SERVICE BULLETIN

FUJI HEAVY INDUSTRIES LTD.

NO : FAS-039

1. SUBJECT : Modification of Engine Mount and Firewall.
2. AIRCRAFT AFFECTED : FA-200 Series Serial Nos. 1 thru 101.
3. PRIORITY : Desirable.
4. REASON : In order to reduce vibration of instrument panel.
5. DESCRIPTION : Engine mount to be replaced and firewall reinforced.
6. ACCOMPLISHMENT : Optional.
7. APPROVAL : This modification will be a minor alteration and therefore subject to the Aircraft Administration rework inspection. Prior to starting this rework, contact Fuji Heavy Industry Ltd for direction and then proceed, since this directive contains structural repair of firewall. JCAB Approved.
8. PARTS REQUIRED : The following parts are required to perform the modification:

FIG. 3. INSTALLATION OF ENGINE MOUNT

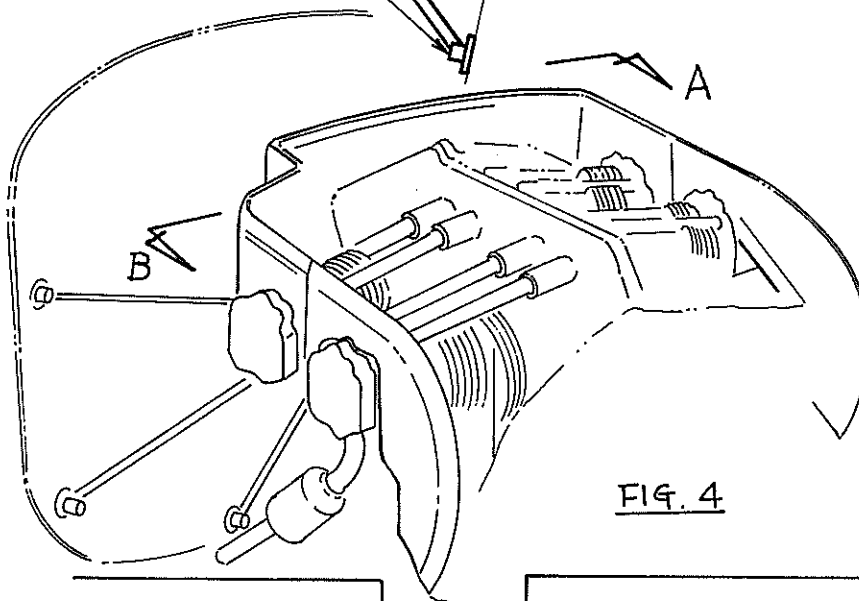
200-412010-611 E/G MOUNT

NAS1305-28D BOLT 2 REQD
 AN310-5 NUT 2 REQD
 AN960-516L WASHER 2 REQD BOLT HEADSIDE
 AN960D516 WASHER 2 REQD NUT SIDE
 MS24665-134 COTTER PIN 2 REQD

NAS1305-25D BOLT 4 REQD
 AN310-5 NUT 4 REQD
 AN960-516L WASHER 4 REQD BOLT HEAD SIDE
 AN960D516 WASHER 4 REQD NUT SIDE
 MS24665-134 COTTER PIN 4 REQD

FIG. 4

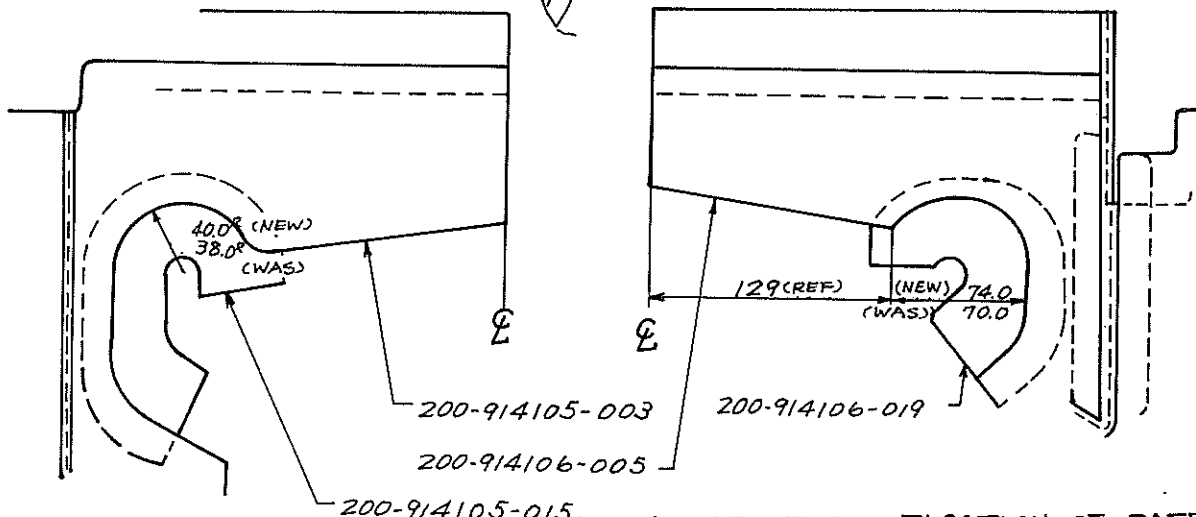
- (r) Existing three holes (upper) for engine mount are no longer required. Plug these obsolete holes with bolts, AN5-7A, nuts, NAS679A5, and washers, AN960-516.
- (15) Remove baffle assemblies, 200-914105-003, 200-914106-005, shown in Fig. 4. (Refer to the manual 4-10-1)
- (16) Rework above baffle assemblies as illustrated in fig. 5 and fig. 6.
- (17) Install reworked baffle assemblies. (Refer to the manual 4-10-2)
- (18) Install engine on new, improved engine mount, 200-412010-601. (Refer to the manual 4-11-2.)
- (19) Install parts that have been removed in steps (4) thru (13). For installation instruction, refer to applicable sections of the manual.
- (20) Install engine mount with engine as shown in fig. 3. (Refer to the manual 4-8.)
- (21) Install upper and lower couplings. (Refer to the manual 4-3-2.)
